SUBJECT: 10 CFR 71.95 Report on the 8-120B Cask for the McGuire Nuclear Station, Units 1 and 2

Subject: 10 CFR 71.95 Report on the 8-120B Cask

**Failure to Observe Certificate of Compliance Conditions
for the 8-120B Vent Port Pre-Shipment Leak Test**

Details of the 8-120B Vent Port Leak Rate Test Setup

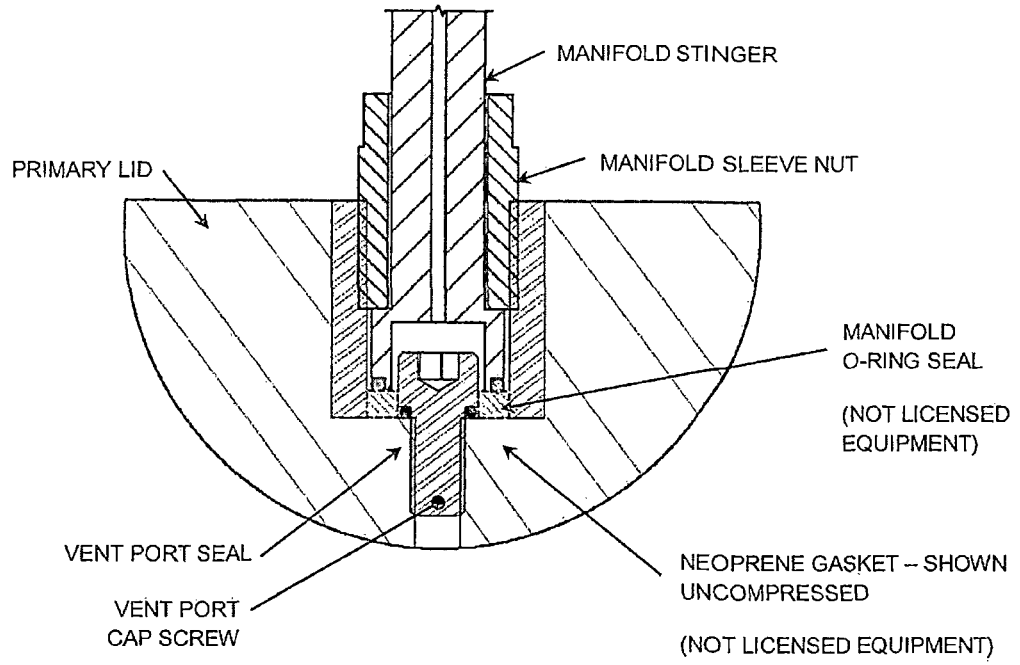
The neoprene gasket can constrict on the head of the vent port plug cap screw when it is compressed by the bottom end of the test manifold stinger, which could reduce the sensitivity of the pre-shipment leak test. Consequently, the vent port pre-shipment leak tests performed using the neoprene gasket may not have provided the required test sensitivity of 1×10^{-3} ref-cm³/sec.

The pre-shipment leak test of the vent port is a pressure drop test performed using a dedicated test manifold. The test manifold is not a part of the licensed package. It includes a stinger (shown below), an O-ring seal that contacts the stinger and the bottom of the vent port hole, and a sleeve nut to compress the O-ring seal. The test manifold was designed so that it surrounds the vent port cap screw, leaving a small gap between itself and the vent port cap screw. The 8-120B cask fleet began to ship with a new lid design in September 2013, and operations staff noted more frequent difficulty getting the manifold to seal. It became desirable to find a better way to seal the bottom of the manifold in order to minimize operator exposure. They found that adding a neoprene gasket (also not part of the licensed package) under the base of the stinger as shown below helped reduce testing time and exposure.

- *EnergySolutions* designed and tested new manifold gasket design that does not constrict onto the head of the vent port plus screw when compressed, and therefore it does not reduce the test sensitivity. The new gaskets have been distributed to all upcoming shipment users. The new manifold gasket design is shown in Attachment 1. The *EnergySolutions* drawing for the 8-120B air drop manifold have been revised to include the new gasket seal, and the air pressure drop test procedure TR-TP-002 has been revised to incorporate the new pre-shipment leak test procedure for the vent port. Use of the new procedure and the new manifold gasket will assure that the pre-shipment leak test satisfies the required test sensitivity and that the manifold gasket is removed from the test port after completing the pre-shipment leak test.

The new manifold gasket design, shown below, replaces the manifold O-ring seal and neoprene gasket previously used with a neoprene gasket that fits within the notch at the base of the manifold stinger.
